SYDNEY OLYMPIC PARK AUTHORITY

Development Application Assessment Report

Application No:	DA 01-05-2025
Application Site:	Land adjacent to 2 Murray Rose Avenue and Bennelong Parkway, Sydney Olympic Park NSW 2127 Lot 87 DP 870992, Lot 2 DP 1122970 and Lot 9 DP 1185060.
Proposed development:	Landscape restoration works
Applicant:	Decode Sydney Pty Ltd
Consent Authority:	Sydney Olympic Park Authority (as delegate of the Minister for Planning and Public Spaces)

Figure 8 Images showing the structural engineering section prepared by Smart Structures Australia (above) inconsistent with the proposed DA drawing prepared by RPS Australia East (below).

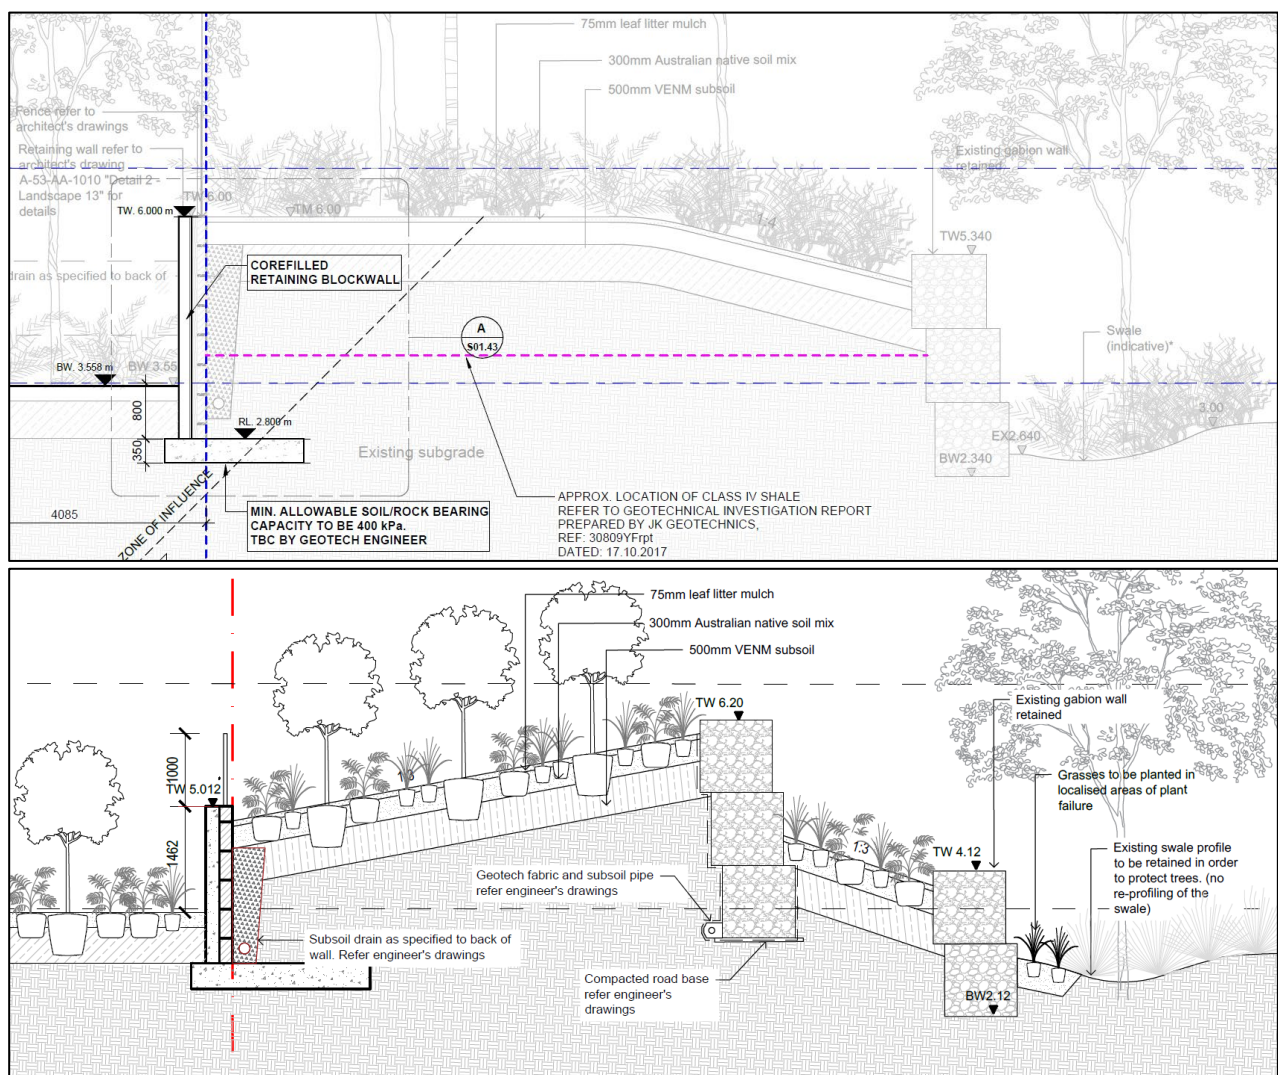
- The structural engineering drawings prepared by Smart Structures Australia for the proposed retaining wall are inconsistent with the proposed DA drawings prepared by RPS Australia East. Section 2 S01.11 in Drawing S01.43 must accurately incorporate the design of the proposed landscaping restoration works shown in drawing titled Sections, L3.00, of the Landscaping Drawings prepared by RPS Australia East (**Figure 8**).

- The proposed drainage of the land restoration works appears to be insufficient. A channel (or swale) is required adjacent to the top of proposed retaining wall to divert stormwater. Similarly, several “holes” through the retaining wall may be required to reduce water accumulation within the mound and pressure build up, minimising potential long term

stability issues with the retaining wall. The Authority seeks to address this through a condition of consent that Drawing S01.43 (Elevation 1 S01.11 and Section 2 S01.11) be amended to incorporate holes for drainage through the retaining wall and incorporates a suitable drainage channel or swale at the top of the mound adjacent to the retaining wall.

Figure 9 Section showing the foundation under SOPA land in red (Source: S01.43, Retaining Wall Details, prepared by Smart Structures Australia, dated 29 April 2025)

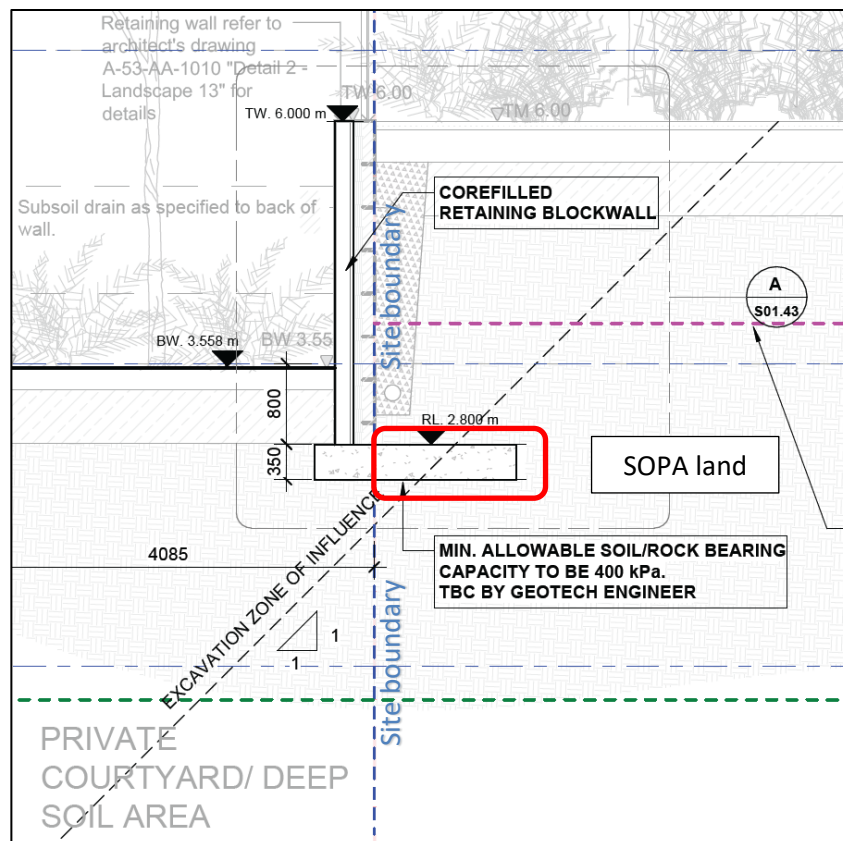
The proposed retaining wall structure includes a foundation or footing located partly on land owned by the Authority (**Figure 9**), totalling approximately 59 square metres. The Authority recommends a condition of consent to ensure that the structural stability and maintenance of the retaining wall, including the footing, be the responsibility of the applicant.

Figure 10 Plan showing the extent of the foundations of the proposed retaining wall in red and site boundary in blue (Source: S01.11, *Retaining Wall Plan*, prepared by Smart Structures Australia, dated 29 April 2025)

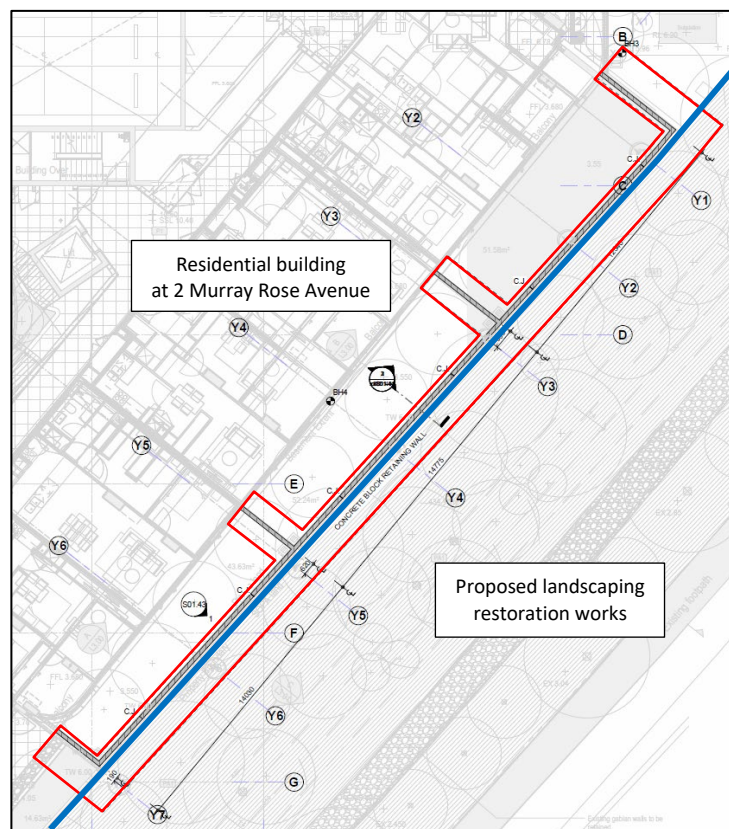
Murray Rose Avenue. The foundations for this retaining wall extend beneath the private courtyards for an approximate area of 58 square metres, reducing the deep soil zone at 2 Murray Rose (Figure 10).

As a result of the works proposed under this DA, this deep soil zone at 2 Murray Rose Avenue reduces from 10.4% to 8.1%. The Authority is satisfied that this reduction in deep soil is satisfactory, as it is minor and maintains compliance with the standards in the ADG.
